HISTORIC AND DESIGN REVIEW COMMISSION

HDRC CASE NO: 2022-429
ADDRESS: 1009 AVENUE B
LEGAL DESCRIPTION: NCB 457 (88 SOCIAL-FOOD TRUCK PARK), BLOCK 35 LOT 10
ZONING: FBZ T6-2, RIO-3
CITY COUNCIL DIST.: 1
APPLICANT: Aldo Mancilla/Harbat Design
OWNER: ALAMO MILLS DAM LLC
TYPE OF WORK: Metal awning structure installation
APPLICATION RECEIVED: July 19, 2022
60-DAY REVIEW: Not applicable due to City Council Emergency Orders
CASE MANAGER: Hannah Leighner

REQUEST:

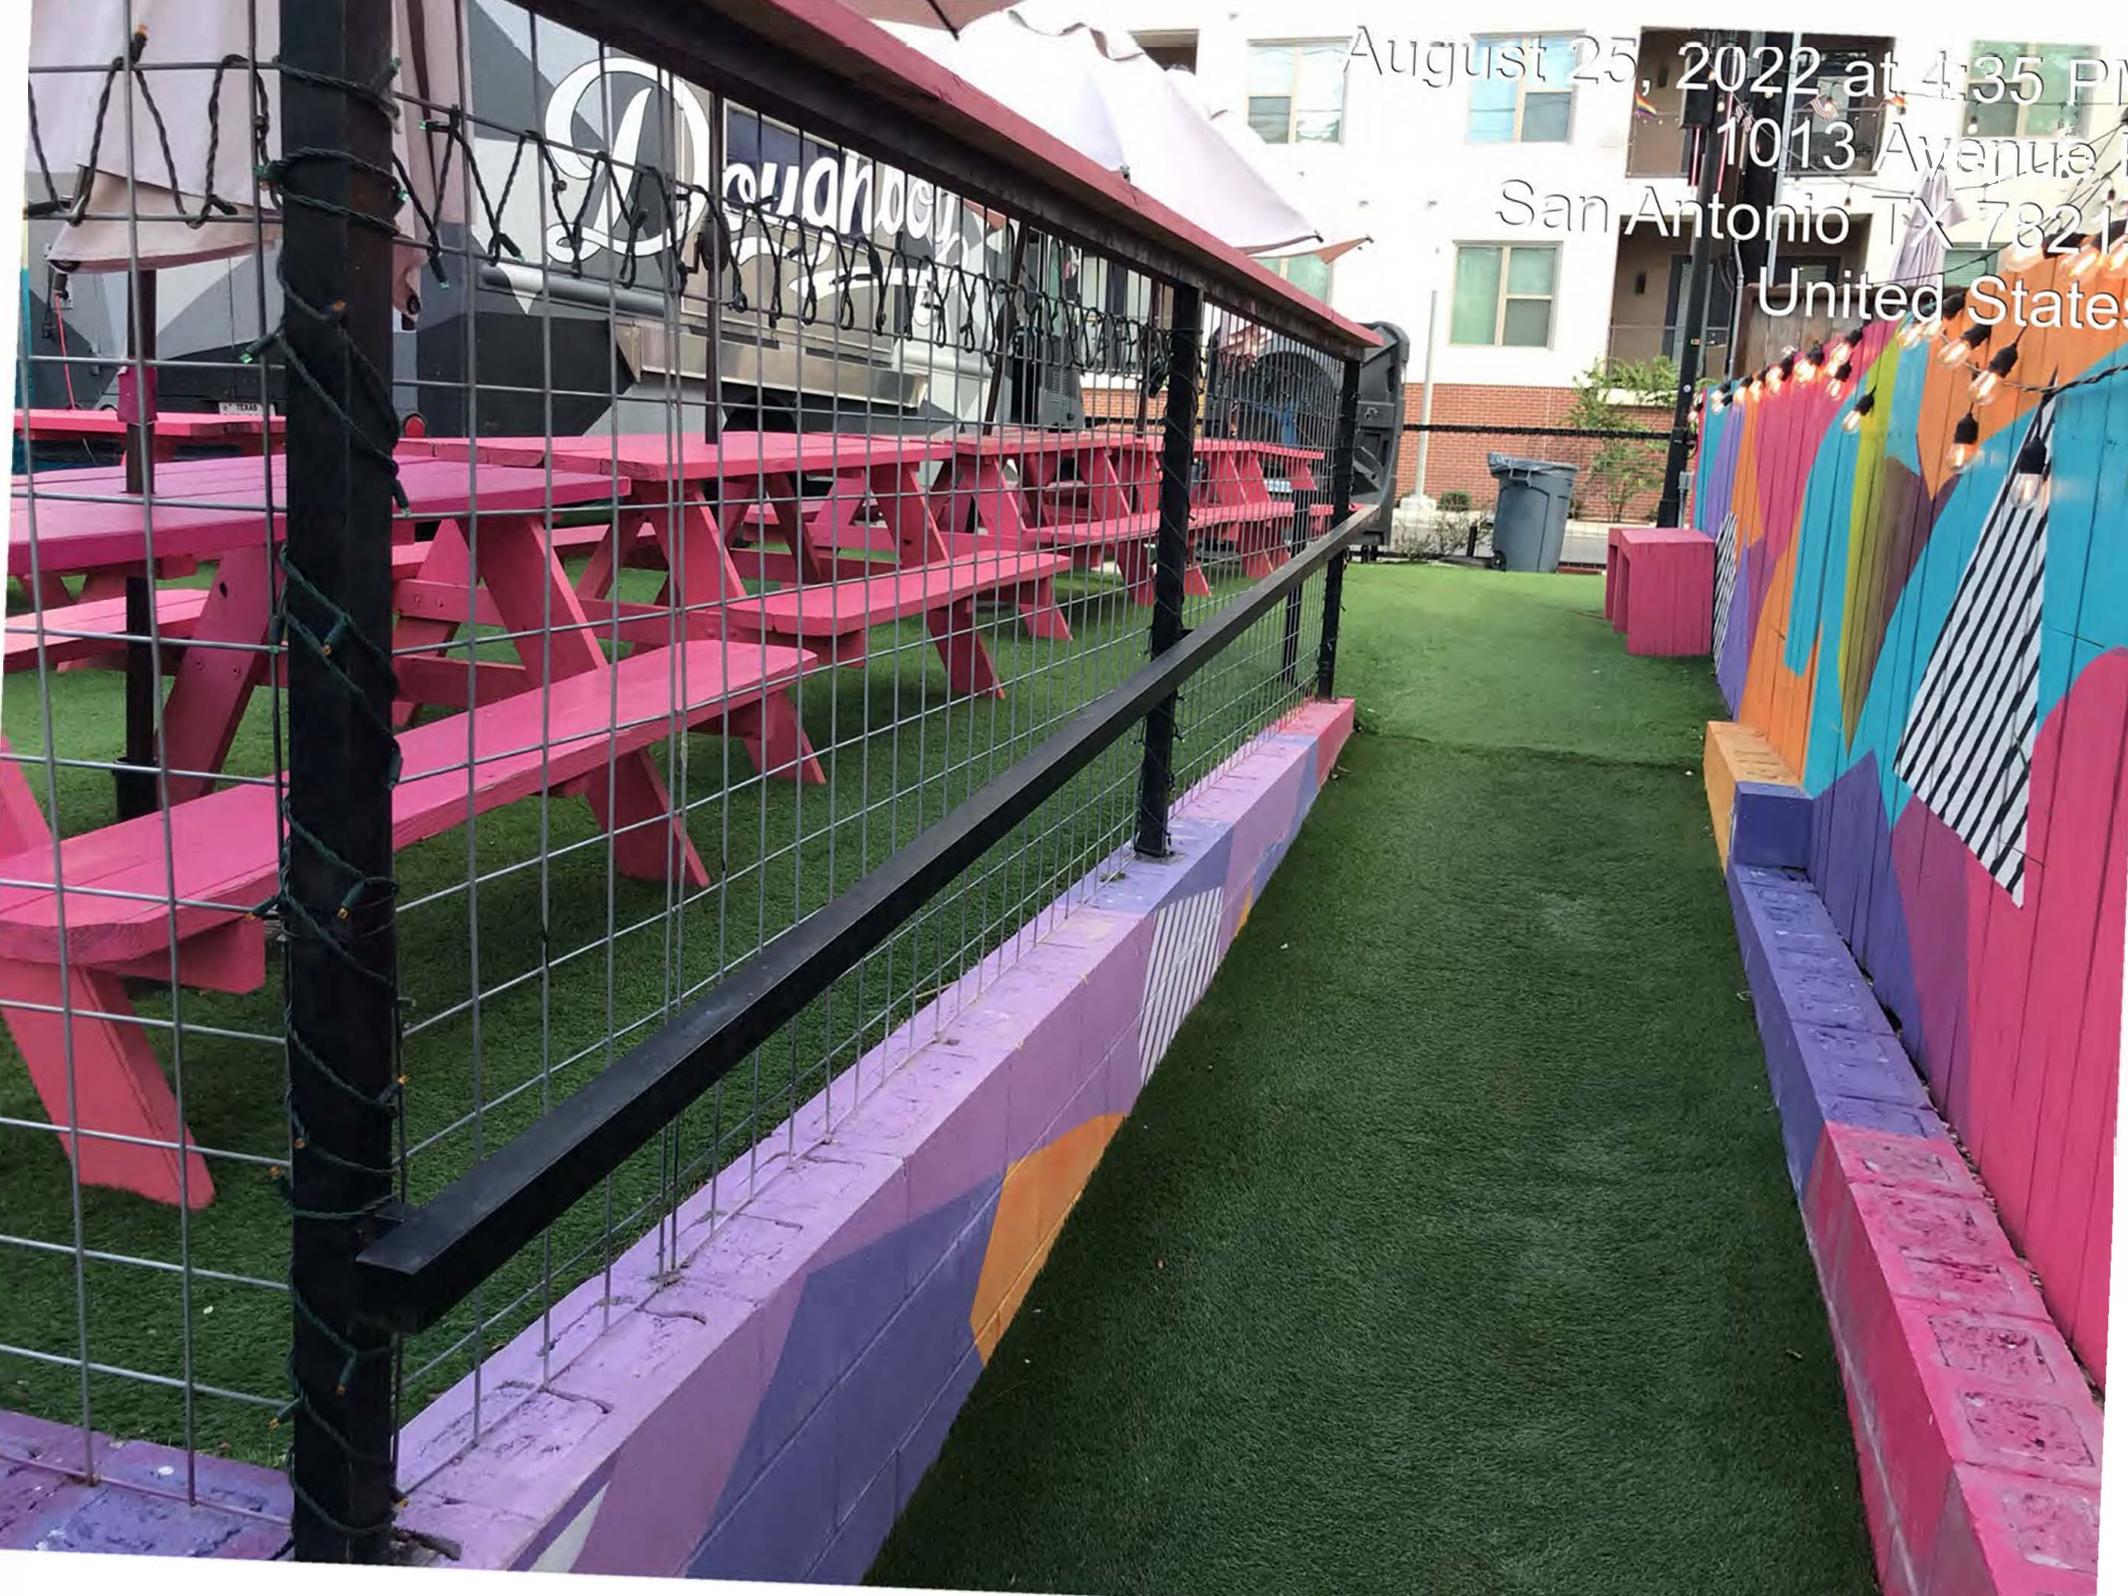
The pink-colored awning (pictured) constructed in violation has been removed and is no longer a part of this request.

The pink-colored awning (pictured) constructed in violation has been removed and is no longer a part of this request.

The pink-colored awning (pictured) constructed in violation has been removed and is no longer a part of this request.
